DEVIATION REQUEST AND DECISION FORM

Project Name : Crossroads at Meadowbrook Mixed Use Preliminary Plan
 Schedule No.(s) : 5408007005
 Legal Description : A portion of Tract B 24/94 Business Park Fil No. 1, as amended by affidavit of correction rec. #219097386

Figure 2-15. Typical Urban Residential Collector Cross Section Traffic volumes up to 10,000/day

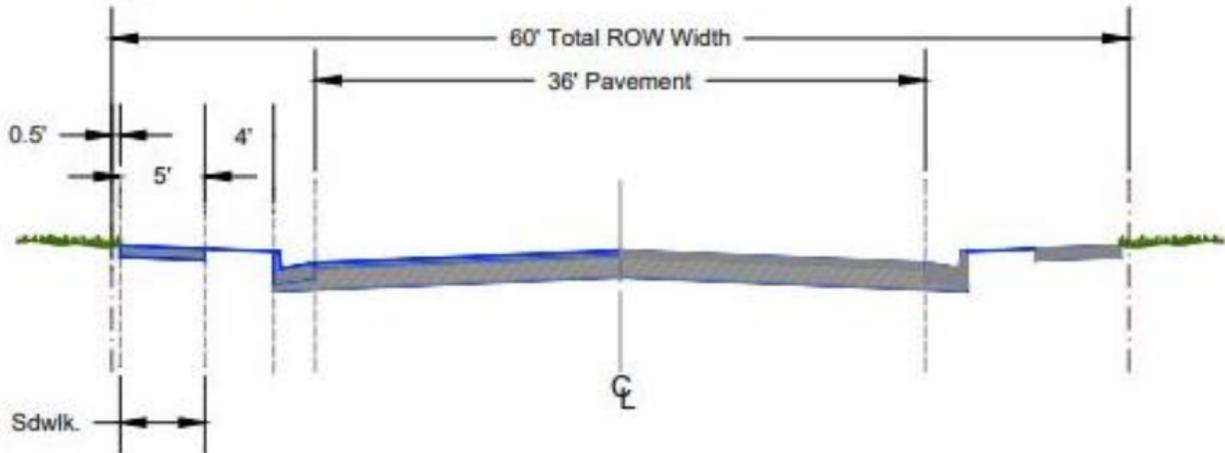
A deviation from the standard Urban Residential Collector Roadway Cross Section is requested. The standard cross section includes two travel lanes within a 36-foot wide pavement mat; two 2.5-foot curb and gutter at the end of the pavement mat; two (2) four (4) foot (typical) landscape/tree lawns; two (2) five (5) foot detached sidewalks all within a 60-foot ROW.

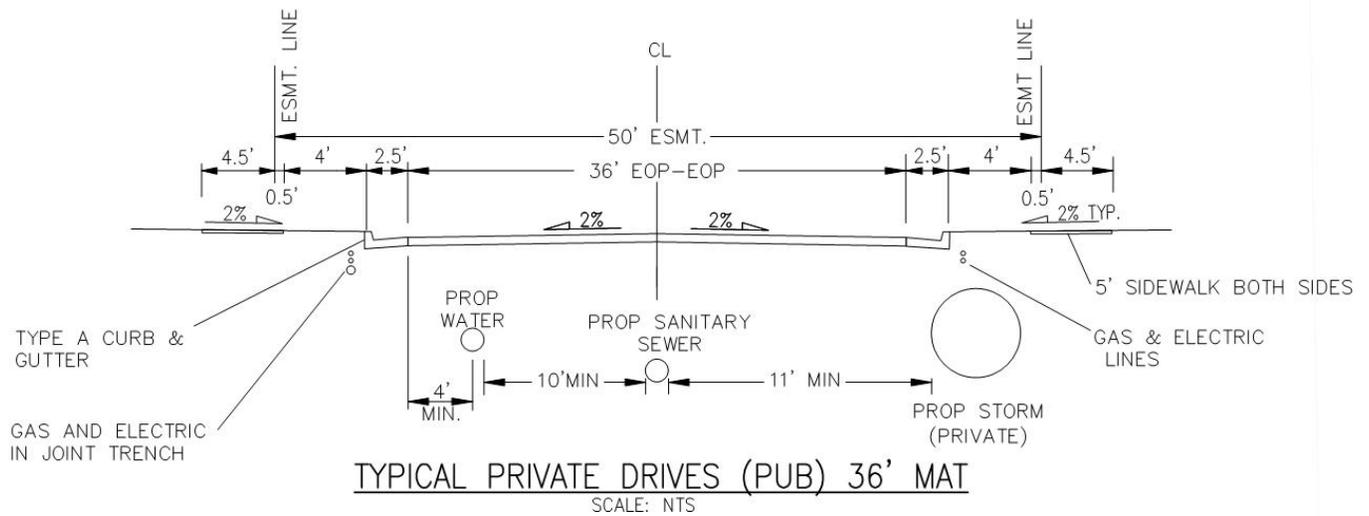
The applicant requests a deviation from the 60-foot ROW width, along with a 4.5' landscape lawn for a private road to be known as Pacific Rail Point.

The proposed private road cross section includes the following deviation from standard ECM Standards for an urban residential collector section.

- 50-foot tract dedicated for private road and utility use. Typical cross section is within a 60-foot Public ROW.
- 36 foot pavement width, where typical cross section has a 36' pavement width. No Change.
- Two 18-foot travel lanes, where typical cross section has two 18-foot travel lanes. No Change
- 5-foot detached sidewalk, where typical cross section has 5' detached sidewalks, No Change. However, the sidewalk is outside of the 50-foot tract. Attached sidewalk is not requested because it may cause problems with future development driveway cuts and ADA ramps.

This request has been determined to have met the criteria for approval. A deviation from **Chapter 2, and Appendix F, SD 4-4** of the ECM is hereby granted based on the justification provided.
